EASTERN CORRIDOR SEGMENTS II and III (PID 86462)

CONCEPTUAL ALTERNATIVES IMPLEMENTATION PLAN

Eastern Corridor Segments II and III
PID 86462

**Figure 35: Frequency of Crashes by Crash Type
Eastern Avenue: SR 125 to US 50**

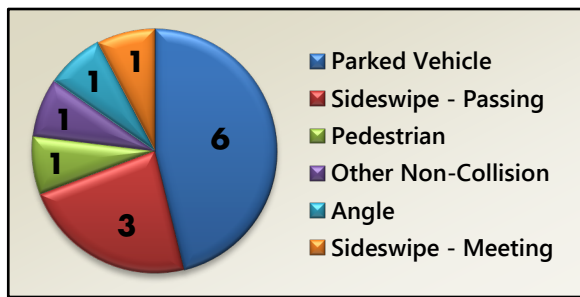
As illustrated in **Figure 35**, there were 13 total crashes in this roadway section during the three-year period between 2013 and 2015. Parked vehicles and sideswipe crashes represent 75% of the total crashes. Although parked vehicle crashes are the most prevalent crashes, they do

not occur at the same location. There is no correlation between the crash data and a specific contributing cause for the crashes. A plot of all 13 crashes is provided in **Attachment A-2**.

**Figure 36: Frequency of Crashes by Crash Type
Wooster Road: Beechmont Circle to Red Bank**

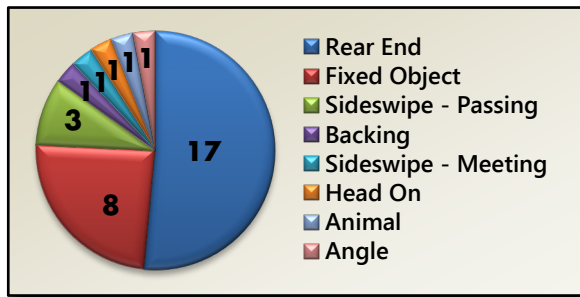
As illustrated in **Figure 36**, there were 33 total crashes in this roadway section during the three-year period between 2013 and 2015. Rear-end and fixed object crashes represent 75% of the total crashes. Of the 33 total crashes on the segment, 25 (75%) occurred in the high hazard section. Within the high hazard segment, 12 of the 25 crashes were rear-end crashes and eight of the 25 were fixed object crashes. There was not a clustering of crashes at a particular location. Half of the rear end crashes occurred between 3:00 PM and 5:00 PM with the majority of crashes occurring during the day in clear conditions. Thirty-three percent (33%) of the rear-end crashes occurred in wet conditions. Other than the observations described above, there was no correlation between the crash data and a specific contributing cause for rear-end crashes.

Seven of the eight fixed object crashes occurred in clear weather, six involved a vehicle traveling southbound, and four occurred in the dark (lighted). Other than the observations described

above, there was no correlation between the crash data and a specific contributing cause for rear-end crashes. See [Attachment A-2](#) for a plot of all 33 crashes.

Figure BIKE-2A (Overall View)
SHARED USE PATH FROM WASSON TRAIL
TO ARMLEDER ROAD

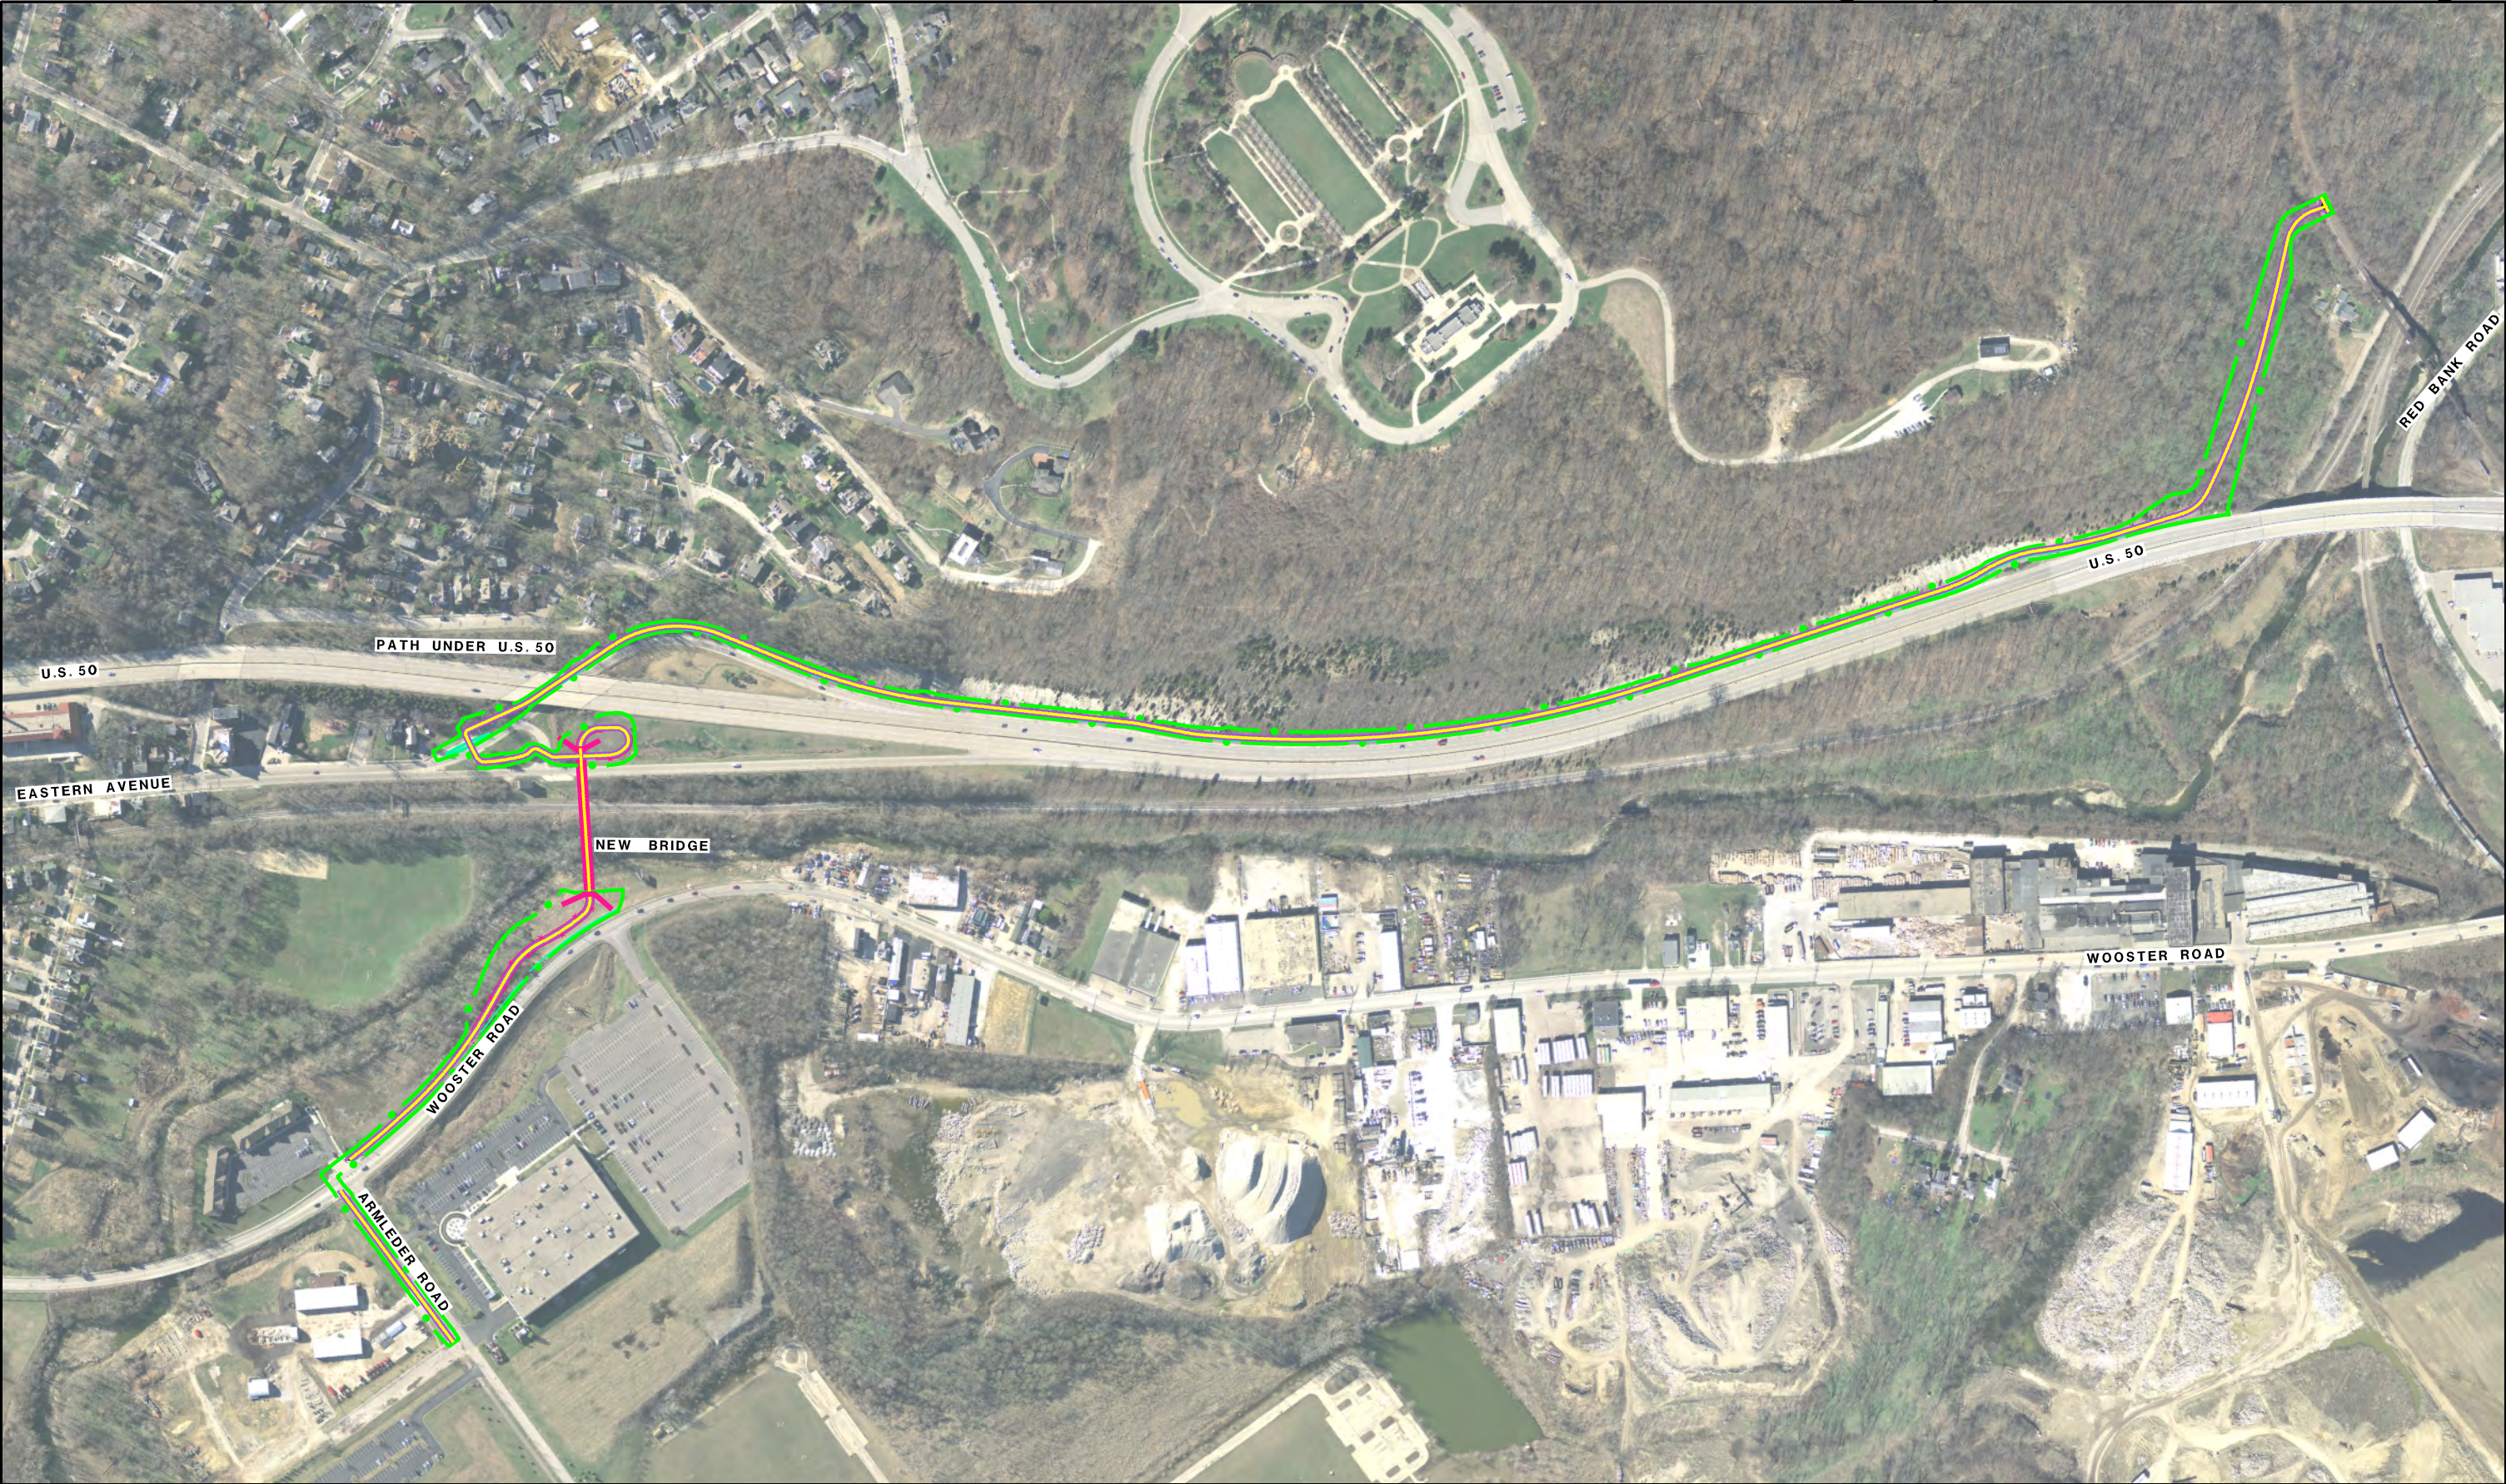
- A barrier-protected shared-use path would be located along right side of westbound US 50.
- The path would follow the existing exit ramp (5% grade) from US 50 to Eastern Avenue, then cross to Armleder Road using the connection established in the BIKE-1 concept.
- No additional comments received following the 5/22 meeting.

- This concept requires construction of a new bridge crossing from Eastern Avenue to Wooster Road. The bridge would be located immediately east of Linwood Park.
- A shared-use path located next to US 50 would need to be separated by a physical barrier; concrete barriers are proposed. Installing concrete barriers would not impact the hillside or shoulder along US 50, but would require modification of the city gateway.
 - One Committee member expressed concern that cyclists would be traveling a long way without an option to exit the path. Another

suggested that, even with the concrete barrier, cyclists might not feel safe, particularly with children traveling so close to vehicular traffic on US 50.

- This project would connect the bike path to Ault Park’s hiking trails, which opens up a larger commuter network to local neighborhoods.
- Consider incorporating the spur to the Murray Trail (as outlined in concepts E6/E7) into this concept.
- The priority of this concept will depend on the status and advancement of the Wasson Way trail.

- Include in the Implementation Plan as a medium priority, including BIKE-2a and BIKE-1a to fully connect Wasson Way Trail to Armleder Park.
- Consider connecting Murray Trail spur.
